APPENDUM # 4 - APPENDIX 'N'

REFERENCE: A001

FIRST FLOOR DEMOLITION PLAN (Revised - Addendum #4)

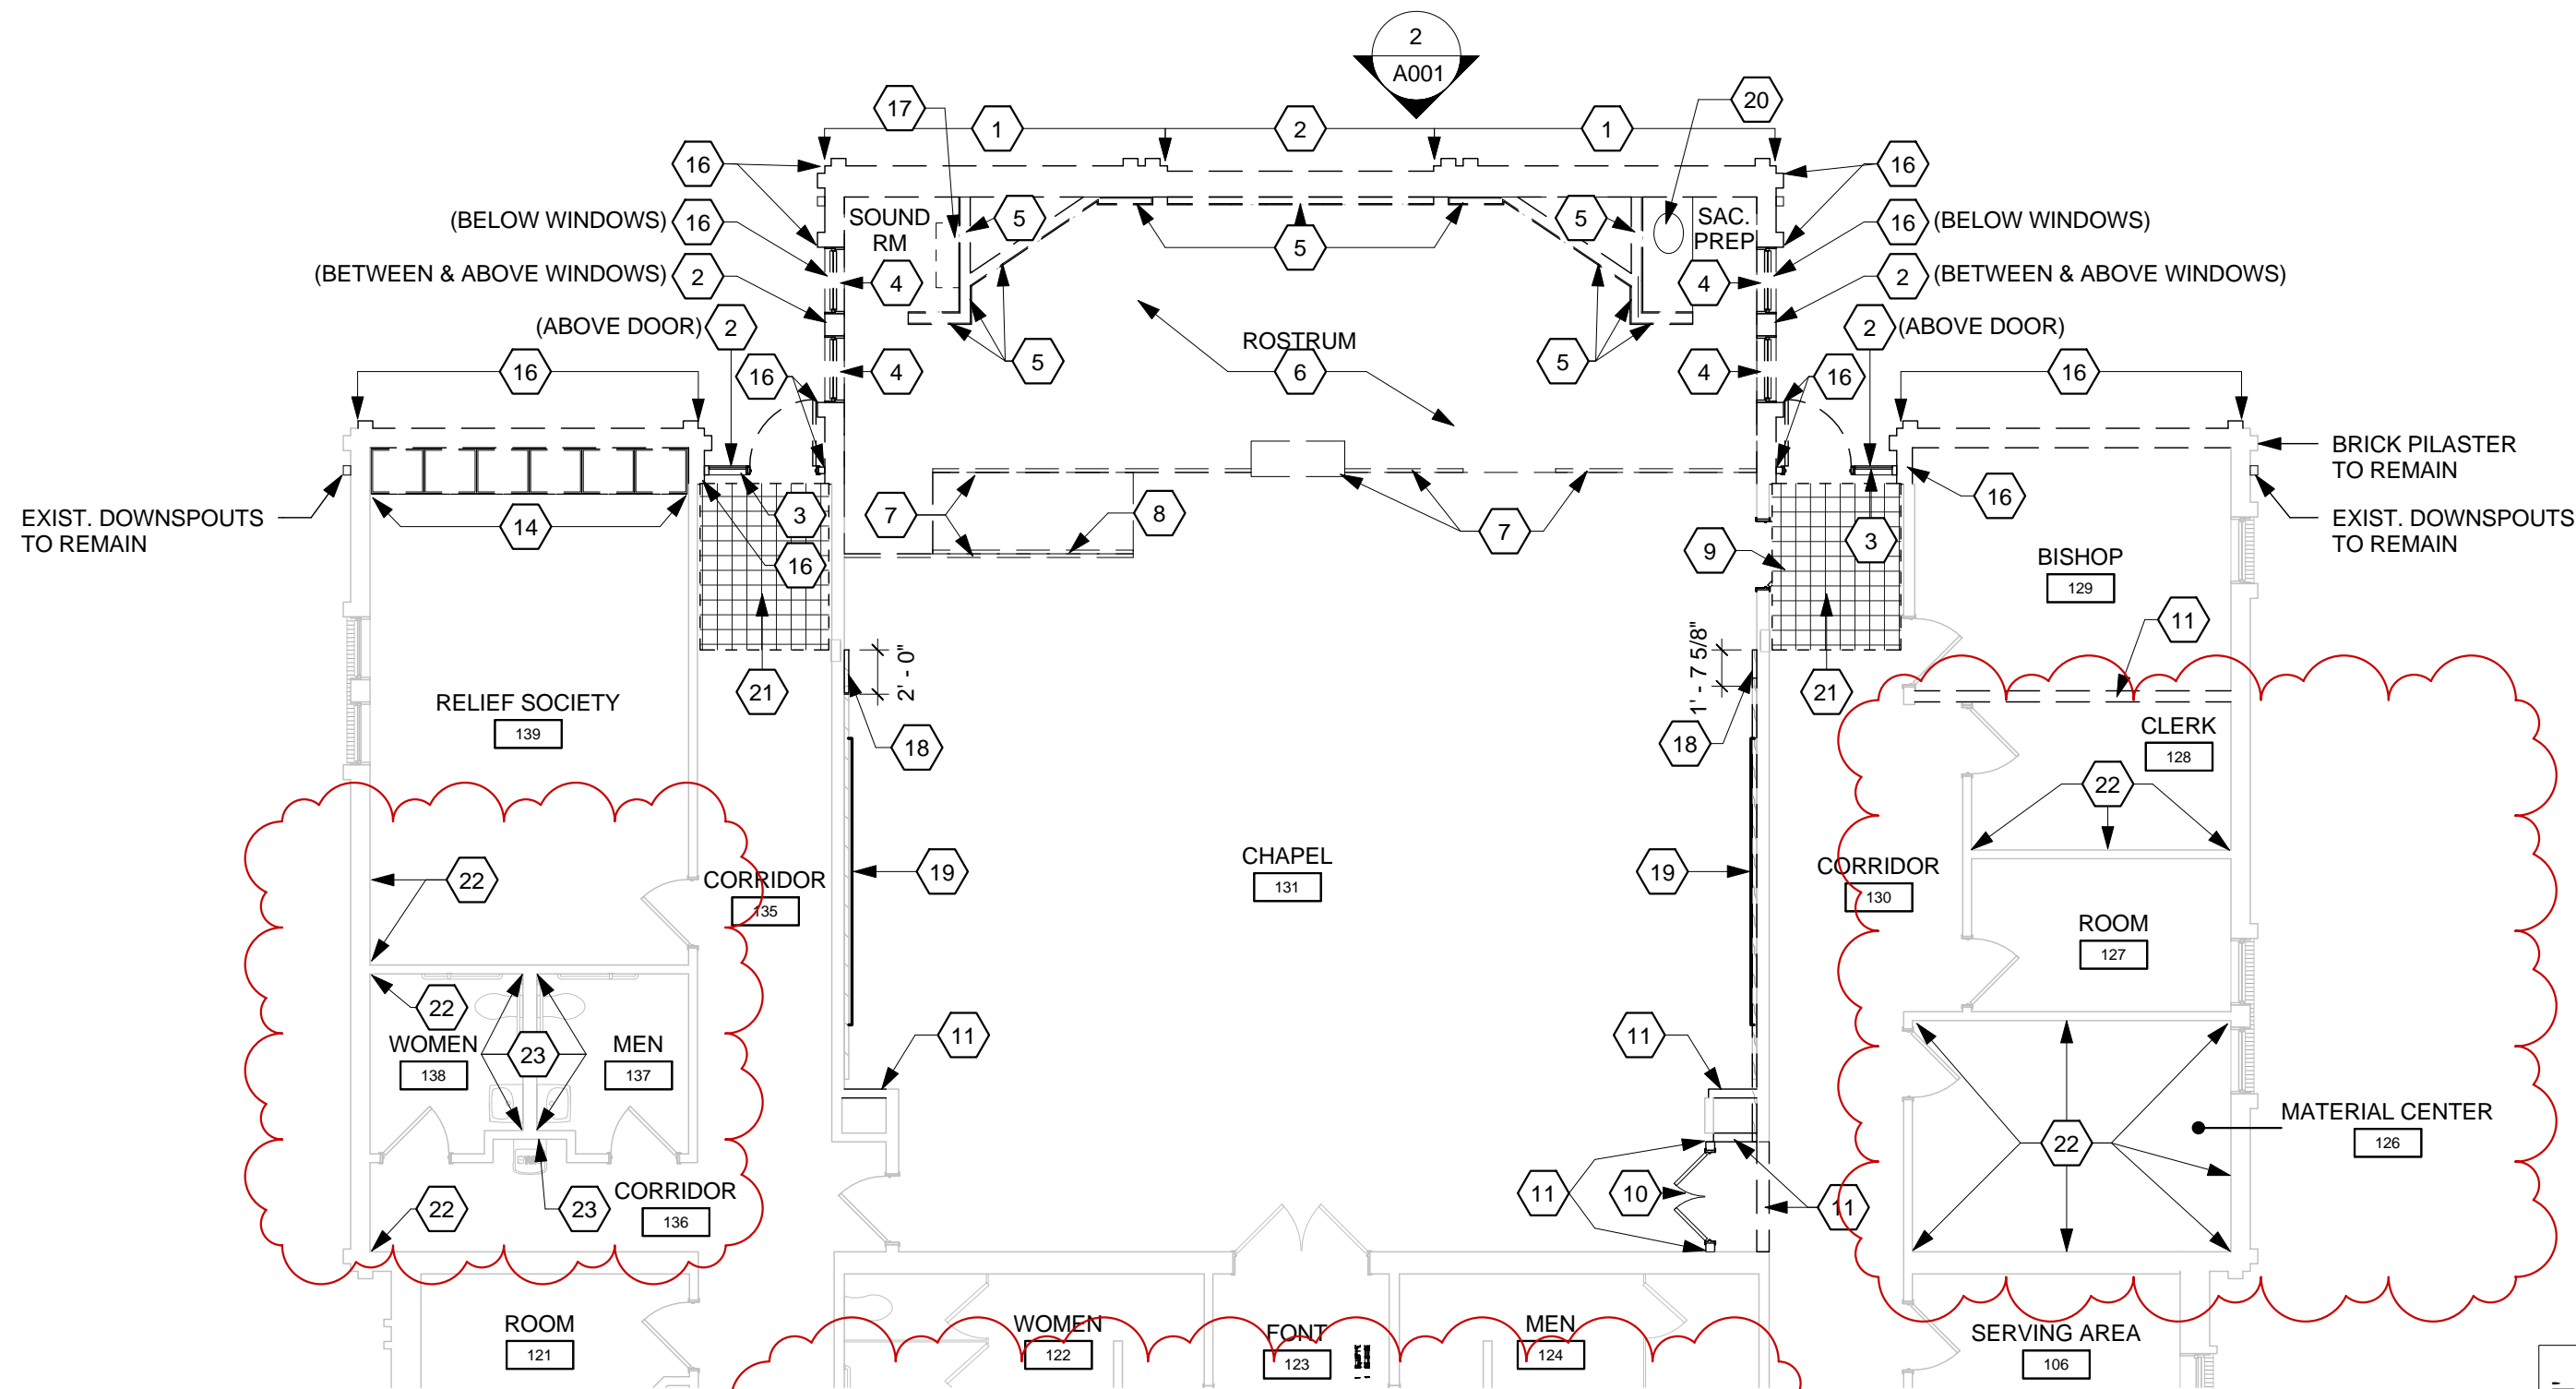
- 22 - PATCH AND/OR REPAIR CRACKS IN EXISTING GYPSUM BOARD FINISH AND PROVIDE TOUCH-UP PAINT TO MATCH EXISTING ADJACENT WALLS.
- 23 - CLEAN OUT GAP IN JOINTS BETWEEN CERAMIC TILE AND GYPSUM BOARD SURFACES, AND GAPS BETWEEN CERAMIC WALL TILES AND CERAMIC FLOOR TILES. PROVIDE FLEXIBLE SEALANT BEAD OVER GAP. SEALANT COLOR TO MATCH GROUT.
